ATTACHMENT A

PROPOSED CHANGE TO APPENDIX A

TECHNICAL SPECIFICATION TO OPERATING LICENSES

NPF-11 and NPF-18

FIGURE 6.1-1

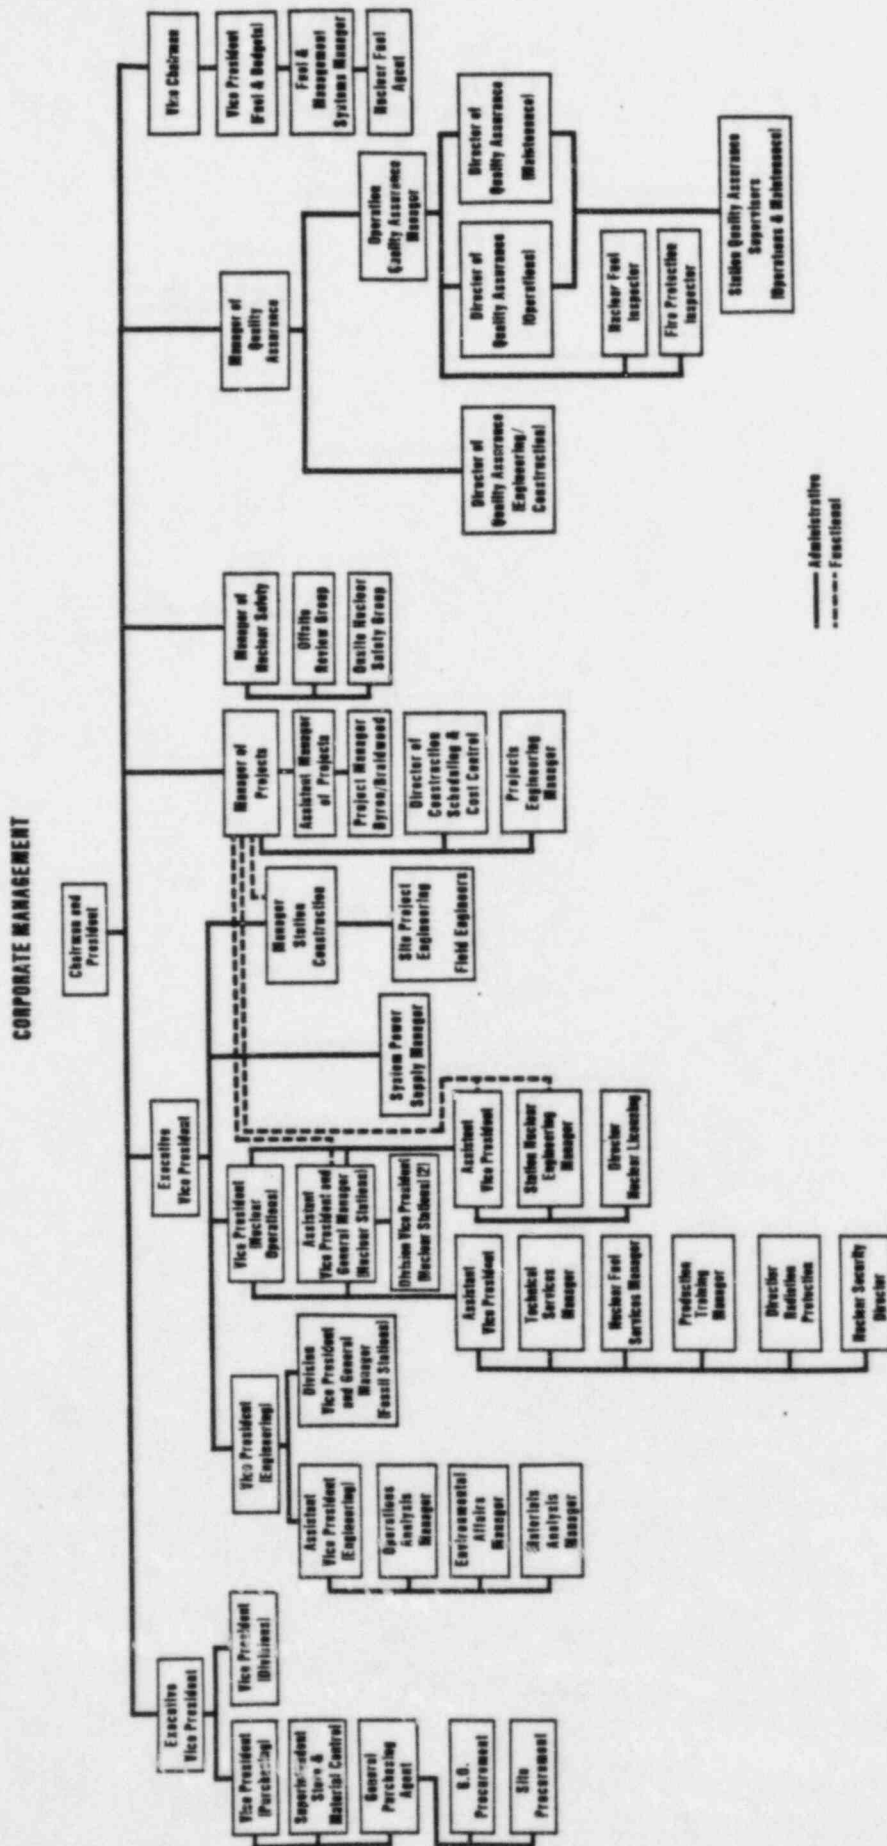
- B. The corporate management which relates to the operation of this station is shown in Figure 6.1-1.

FIGURE 6.1-2

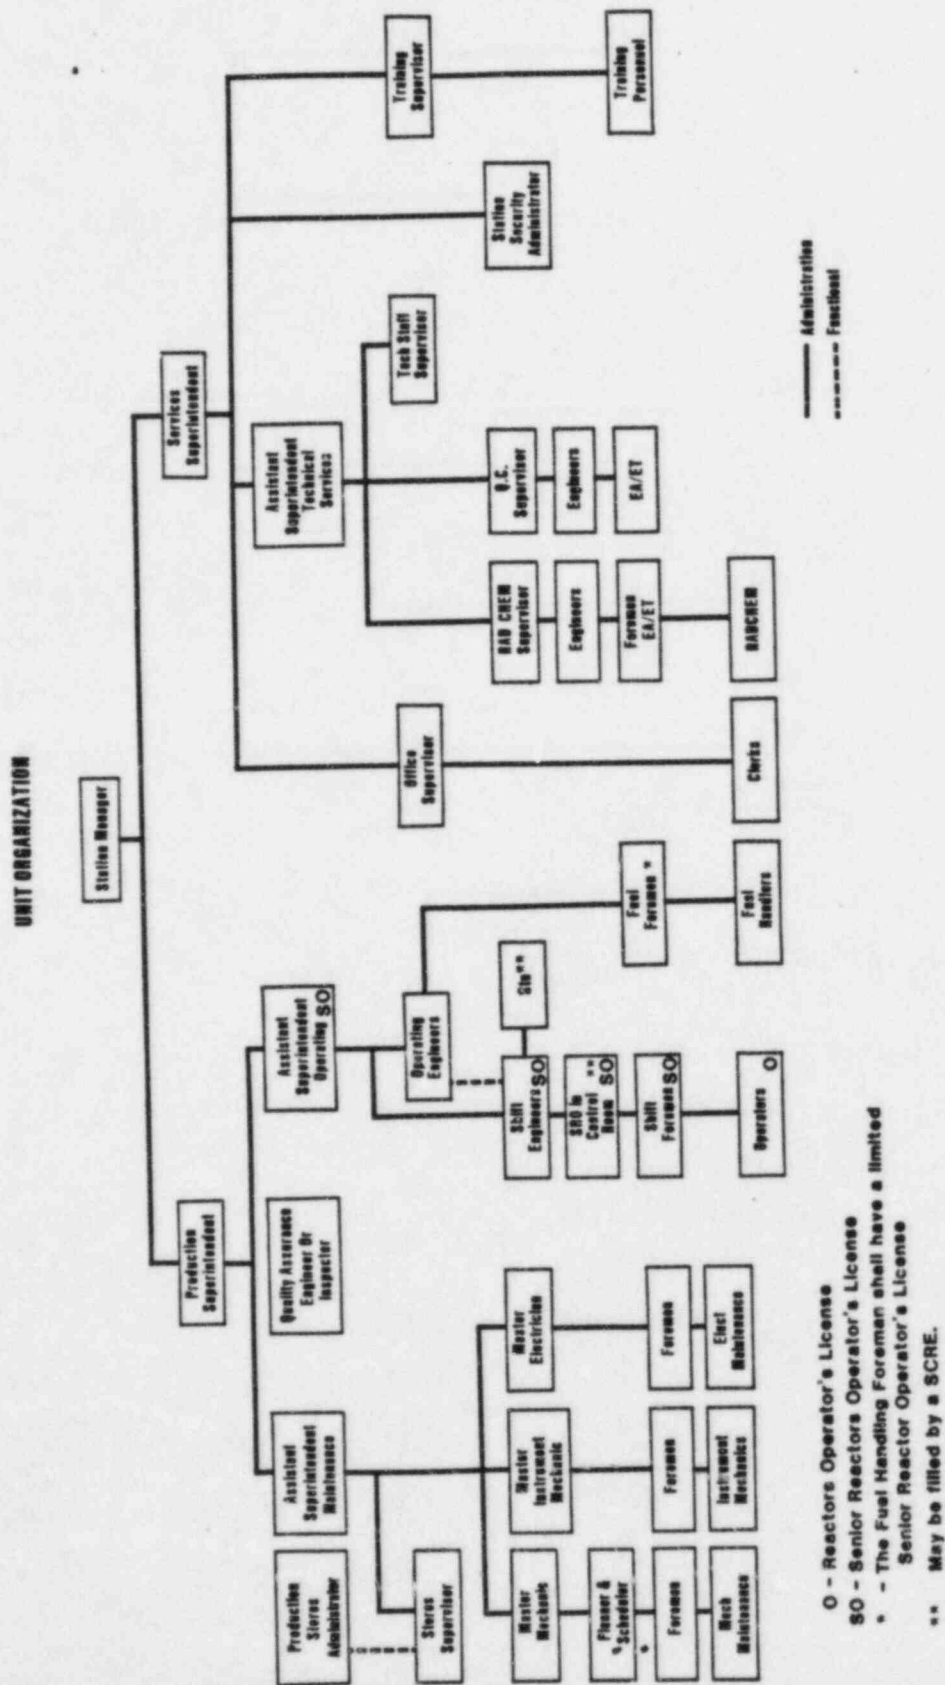
**Figure 6.1-2 indicates that the Operating Assistant Superintendent is required to hold an SRO license. The following exemption from this requirement is authorized. ~~On~~ September 30, 1983:

An individual who meets the requirements of ANSI N18.1-1971, for the ANSI positions of Plant Manager and Operations Manager, with the sole exception that he does not hold a current SRO license at LaSalle, will be allowed to assume the position of Operating Assistant Superintendent, providing

- a. He sits for the SRO examination at LaSalle no later than the first opportunity after six months following his appointment to the position.
- b. Operating decisions made by this individual prior to his holding a current SRO at LaSalle shall be approved by, or directed through, individual(s) holding a current SRO license at LaSalle.

FIGURE 6.1-1

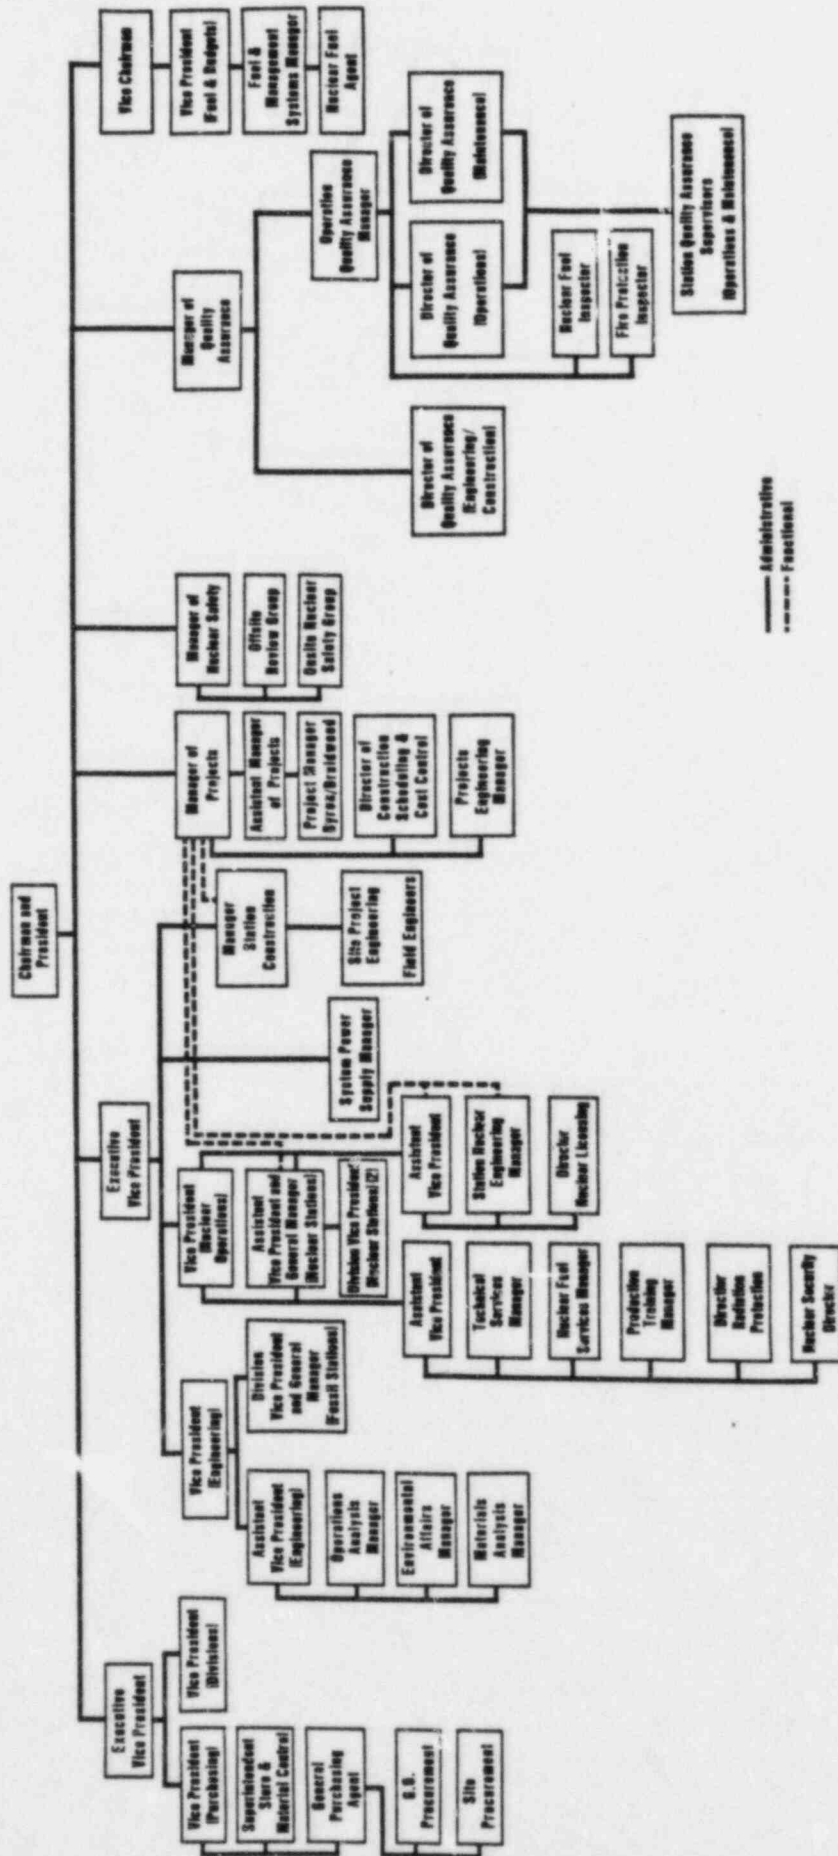
- B. The corporate management which relates to the operation of this station is shown in Figure 6.1-1.

FIGURE 6.1-2

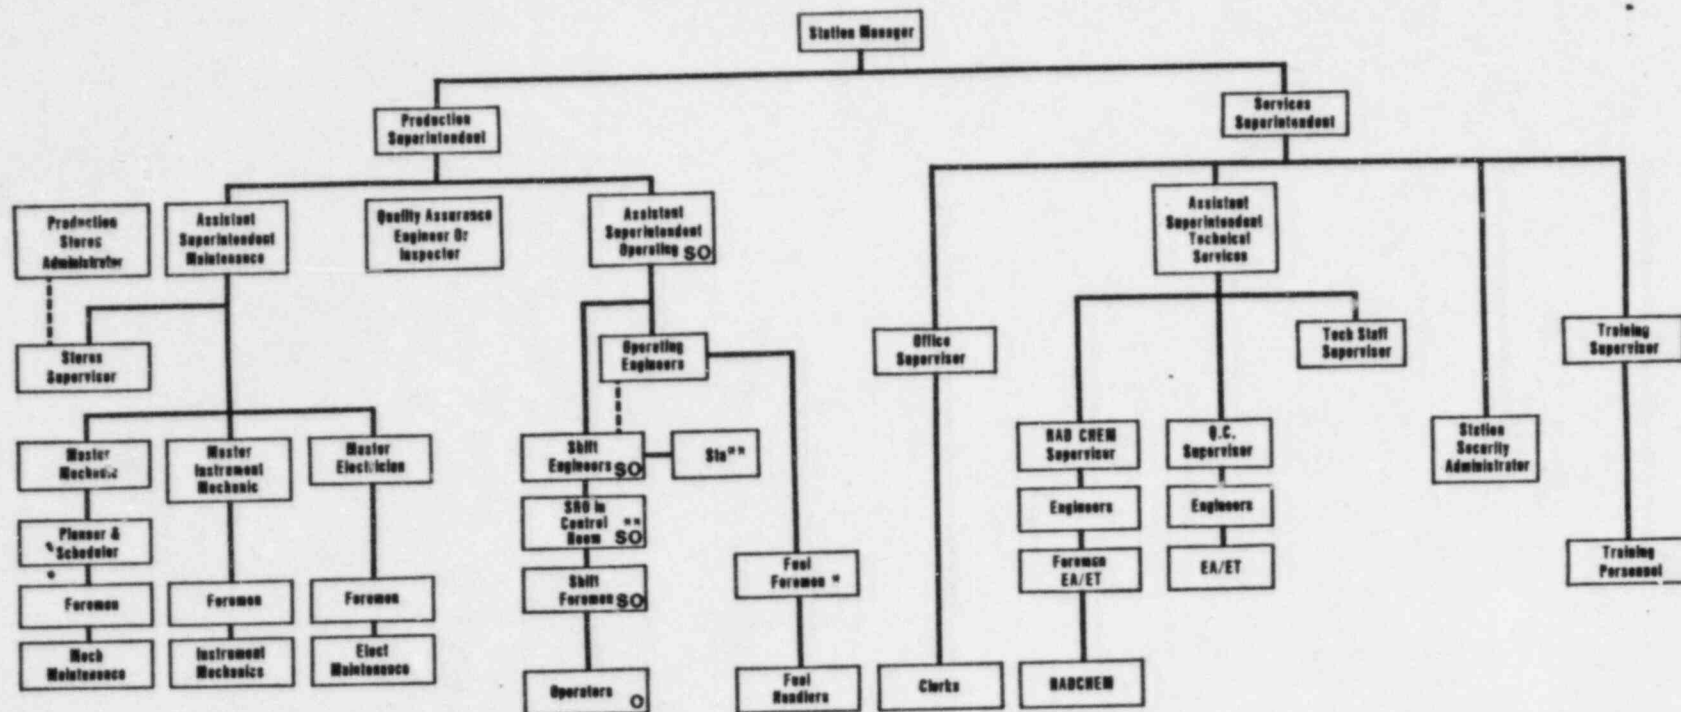
- C. The normal functional organization for operation of the station shall be as shown in Figure 6.1-2. The shift manning for the station shall be as shown in Figure 6.1-3. The individual filling the position of Assistant Superintendent ~~and Support Services~~ shall meet the minimum acceptable level for "Technical Manager" as described in Section 4.2.4 of ANSI N18.1-1971.
